# UNITED STATES PATENT AND TRADEMARK OFFICE

APPLICATION NO.	FILING DATE	FIRST NAMED INVENTOR	ATTORNEY DOCKET NO.	CONFIRMATION NO.
10/820,186	04/07/2004	Thomas R. Marsh	9066-23DV	7421
20792 7590 05/07/2007 MYERS BIGEL SIBLEY & SAJOVEC PO BOX 37428 RALEIGH, NC 27627			EXAMINER LUGO, CARLOS	
			ART UNIT 3676	PAPER NUMBER
			MAIL DATE 05/07/2007	DELIVERY MODE PAPER

## Office Action Summary

### DETAILED ACTION

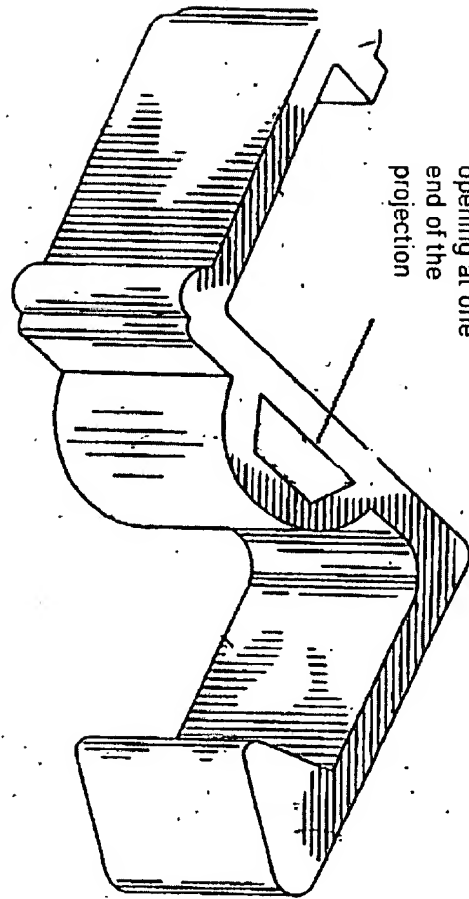
The drawing objection has been withdrawn in view of the explanation given by the applicant, in which the opening referring to in claim 9 is an opening at either side of the cushioning device (for example, Figure 2, where 124 is pointing, and not that the cushioning device is open at one end (see attachment #1).

opening at one  
end of the  
projection

→ incorrect  
interpretation

Attachment #2

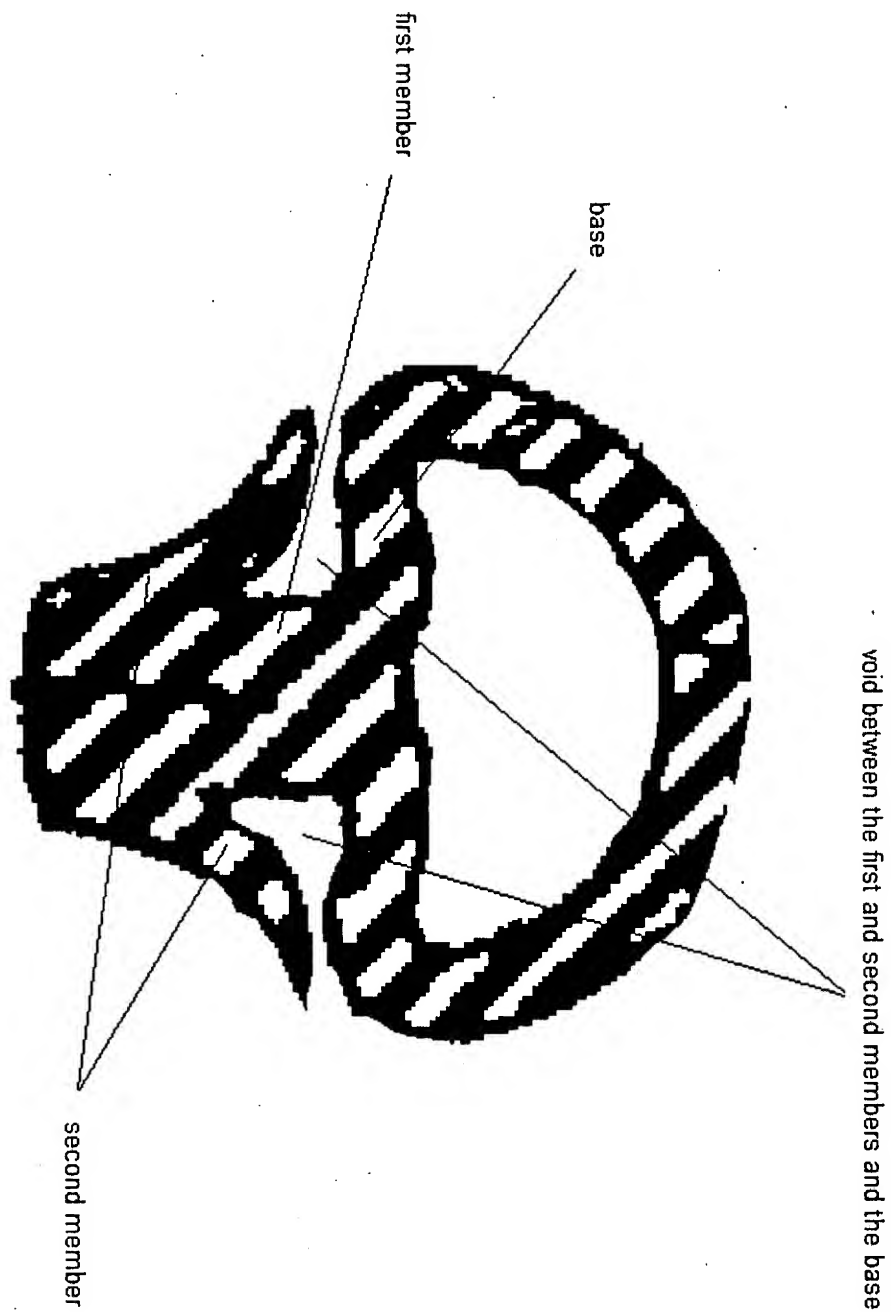
As seen in attachment #2, Schanz clearly illustrates this limitation. The applicant needs to clearly claim the invention illustrated in figure 5 so as to overcome this rejection. Therefore, the rejection is maintained.

opening at one  
end of the  
projection

→ correct  
interpretation
